Access Compliance Report

Public Rights-of-Way

Intersection ID: 20039	Main Street: PROVIDENCE_RD	Cross Street: MAMMOTH_OAKS_DR	Location: E
ADA ID: B8A18706A0F8	Ramp Type: PerpDiag	Initial Pass/Fail: Fail	Overall Compliance: No
		Severity Score: 37.5

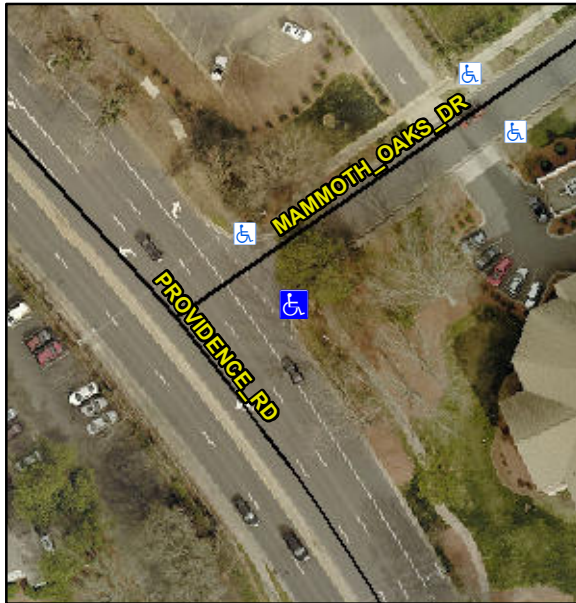
Not Found, R304.2.2, R304.5.3

Compliance	Description	Data	Compliance	Description	Data
N/A	Ramp Length (in)	60.0	No	Ramp Slope (%)	9.3
Yes	Ramp Width (in)	48.0	No	Ramp XSlope (%)	8.6
N/A	Flare Type LT	N/A	N/A	Flare Type RT	N/A
N/A	Flare Slope LT (%)	N/A	N/A	Flare Slope RT (%)	N/A
N/A	Flare Traversable LT?	N/A	N/A	Flare Traversable RT?	N/A
N/A	Landing Length (in)	N/A	N/A	DWS Provided?	N/A
N/A	Landing Width (in)	N/A	N/A	DWS Contrast?	N/A
N/A	Landing Slope (%)	N/A	N/A	DWS Length (in)	N/A
N/A	Landing X Slope (%)	N/A	N/A	DWS Full Width?	N/A
N/A	Landing Curb? (Y/N)	N/A	N/A	DWS Offset (in)	N/A
N/A	Shared Landing?	N/A			
N/A	Gutter Ponding?	N/A	N/A	Gutter Slope (%)	N/A
N/A	Gutter Lip Ht (in)	N/A	N/A	Gutter X Slope (%)	N/A
N/A	Painted X Walk1?	No	N/A	Painted X Walk2?	No
	X Walk 1 Direction	To NW		X Walk 2 Direction	To SW
N/A	X Walk 1 Width (in)	N/A	N/A	X Walk 2 Width (in)	N/A
	X Walk 1 Slope (%)	8.5		X Walk 2 Slope (%)	11.2
	X Walk 1 X Slope (%)	10.4		X Walk 2 X Slope (%)	4.8

Remove & Replace Curb Ramp With Two New Directional Ramps or Equivalent.
